Serial No.: 10/633,635
Docket No.: OD02062US
NIS.061

REMARKS

AMENDMENTS TO THE DRAWINGS:

FIG.10

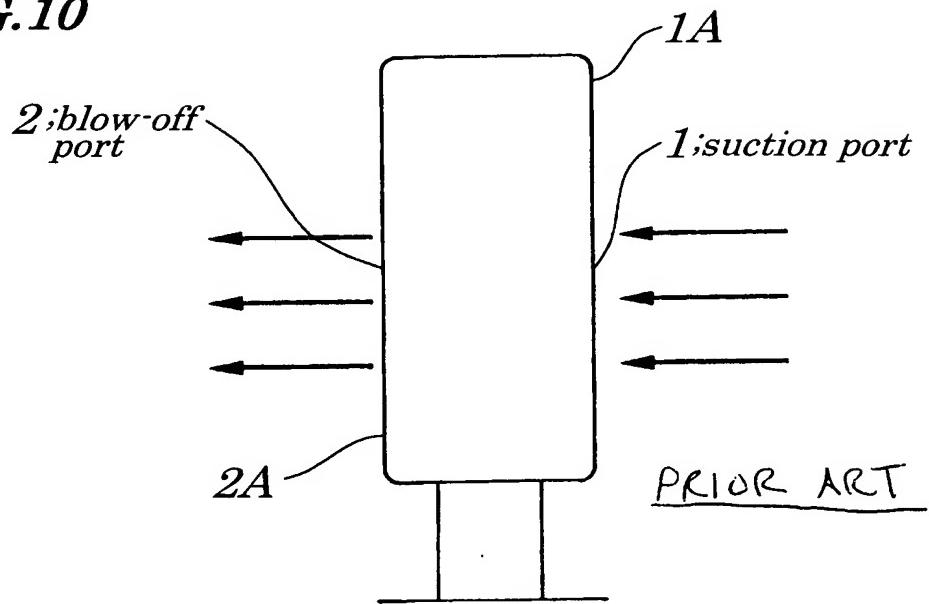
The Office Action objects to Figures 10 and 11. The attached Request for Approval of Drawing Corrections amends Figures 10 and 11 to label them as prior art.

In Figures 10 and 11, a legend indicating that the illustrations are prior art has been added, as requested by the Examiner.

The attached annotated sheet of drawings includes changes to Figures 10 and 11.
